REMARKS

II. DRAWING OBJECTIONS

AMENDMENTS TO THE DRAWINGS

FIG. 1

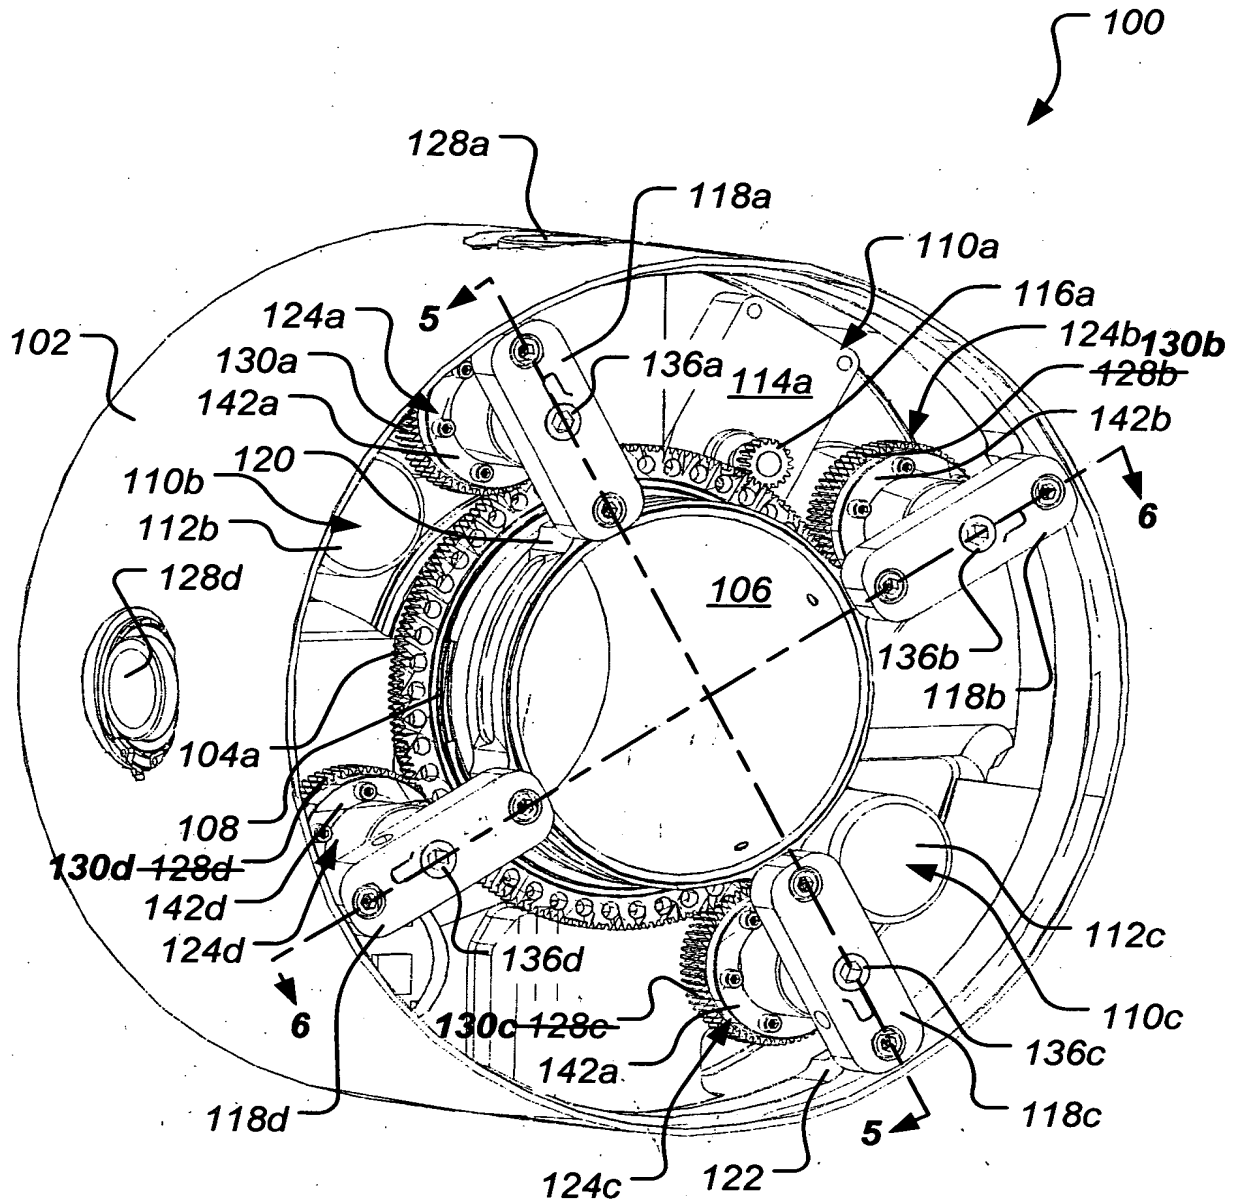
The Office Action indicates that the Drawings are objected to because reference characters "128b-128c" have been used to designate two different elements in Figure 1. Moreover, reference character "128d" has been used to designate two different elements in Figure 1. Accordingly, a new replacement sheet including Figure 1 is appended hereto, wherein 128b, 128c, and 128d have been changed to 130b, 130c,

and 130d, respectively. Accordingly, it is respectfully requested that the objection to the Drawings be reconsidered and withdrawn.

The attached sheet of drawings includes changes to Figure 1. This sheet, which includes Figure 1, replaces the original sheet including Figure 1. In Figure 1, element numbers 128b, 128c, and 128d, labeling roll gears, have been changed to element numbers 130b, 130c, and 130d, respectively.
